ADDENDUM NUMBER 2

Date: June 12, 2015

Re: CRF Deferred Maintenance School of Music EMS/HVAC
University of South Carolina

A/E Proj. No.: 153192

1 PARTIAL FLOOR PLAN - ELECTRICAL RENOVATION
E1 SCALE: 1/8" = 1'-0" PENTHOUSE

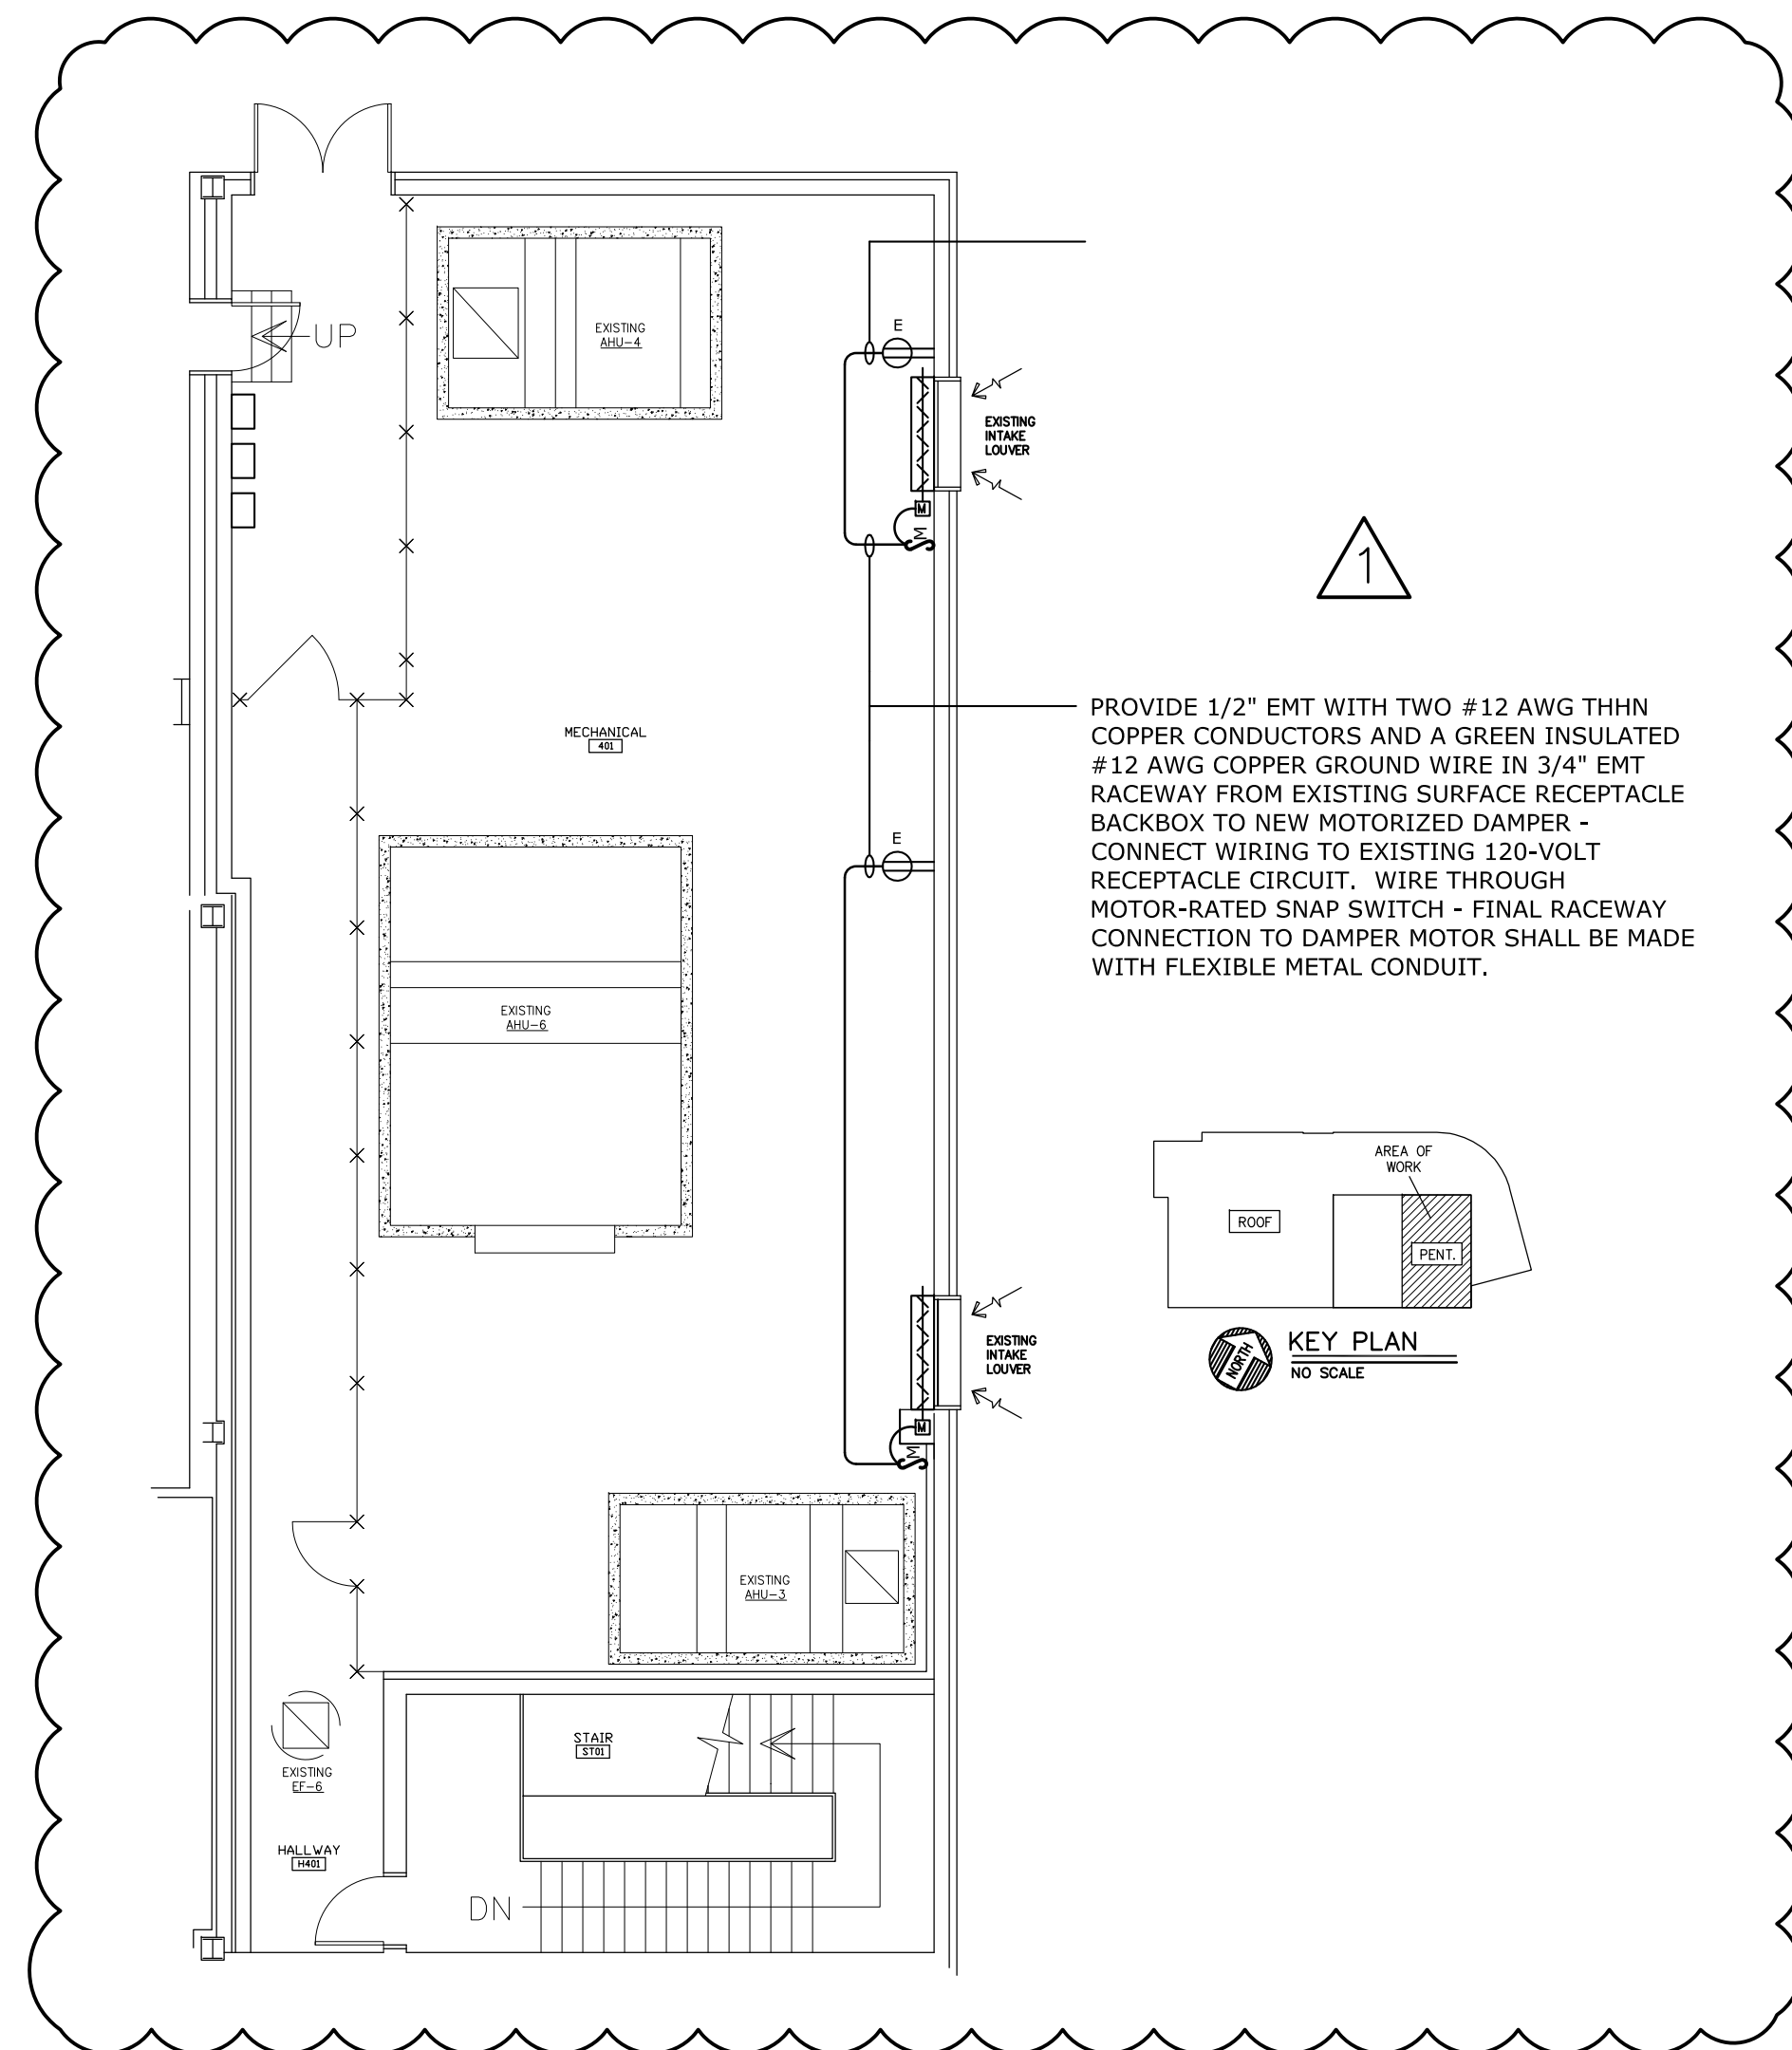
1. See attached revised E1 drawing. Added electrical power for 2nd louver.

| | DETAIL 1 - ADDED DAMPER |
